AMENDMENT OF SOLICITATION/MODIFICATION OF CONTRACT

Solicitation 1240LT26Q0066, Chilao Campground Water System Rehabilitation, Angeles National Forest, is amended as follows:

Amendment 01
Chilao Campground Water System Rehabilitation
1240LT26Q0066
June 24, 2026

TYPICAL TRENCH BEDDING SECTION VIEW
N.T.S.

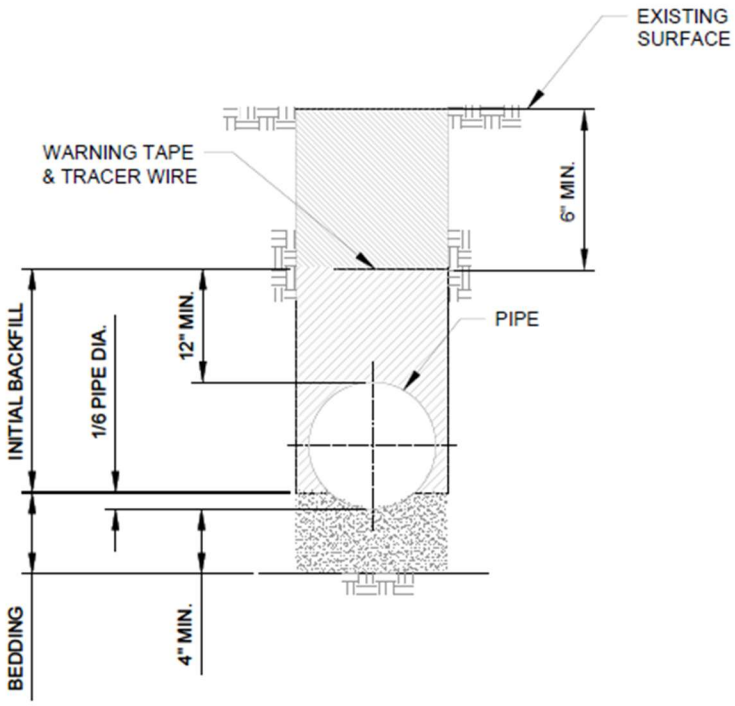
1. **On Sheet D-01 / Pipe Detail, the trench bedding detail appears to be missing some dimensional information. Please provide the complete trench detail dimensions, including trench width, bedding depth, pipe cover, warning tape/tracer wire location, and backfill requirements.**

Page D-01 has been updated to better show the dimensions. The layer text was set on the wrong plot style. Tracer wire shall be 6" minimum from the surface and 12" minimum from the top of the pipe. The bedding shall be a minimum of 4" with 1/6 the pipe diameter set in the bedding. Please see attached drawing.
